Seismic Walkdown Checklist (SWC)

Equipment ID No. 1AE205 Equip. Class¹² (19) Vertical Tanks or Heat Exchangers

Equipment Description Residual Heat Removal Heat Exchanger

Location: Bldg. Reactor Floor El. 177 Room, Area Room 102
Enclosure

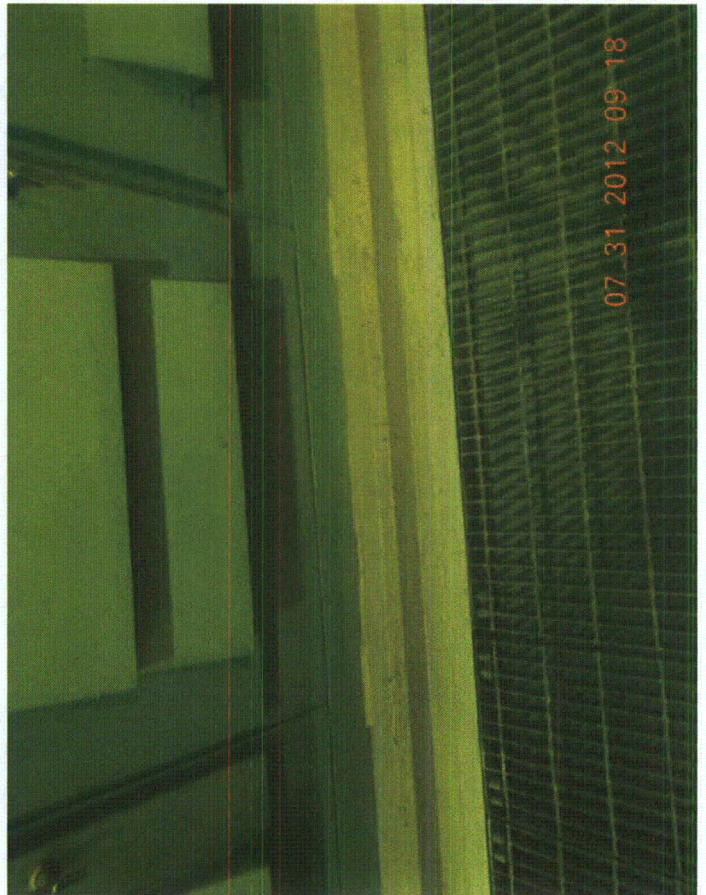
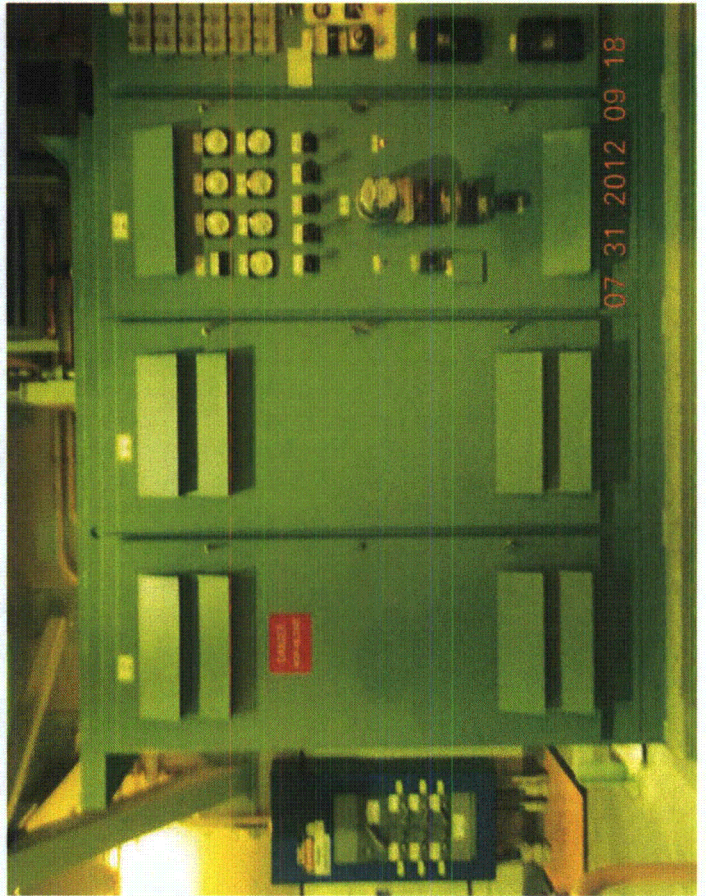
4. Is the anchorage free of visible cracks in the concrete near the anchors? Y N U N/A
 (NW) Front left corner has been repaired and appears to be free from any crack / defect. OK

5. Is the anchorage configuration consistent with plant documentation? Y N U N/A
 (Note: This question only applies if the item is one of the 50% for which an anchorage configuration verification is required.)
 Drawing shows anchor bolts. field should stick weld. Configuration is different.

- 7. Are soft targets free from impact by nearby ^{adj} equipment or structures? Y N U N/A
there is an overhead light bulb in the high ceiling. if that falls, and falls the cabinet with soft instruments, there is a vent hood on the top of cabinet on the path to hit (see comments) that will give it a parabola path that will prevent it from hitting those soft targets.

- 8. Are overhead equipment, distribution systems, ceiling tiles and lighting, and masonry block walls not likely to collapse onto the equipment? Y N U N/A
no masonry block walls. HVAC line is ~~not~~ solid. all the big wires come from the bottom. ^{adj} the above cable tray is less than 50% full. OK. Fittings appear ~~adequately~~ ^{adequately} attached

Soft targets are not in potential falling path of fluorescent bulbs.
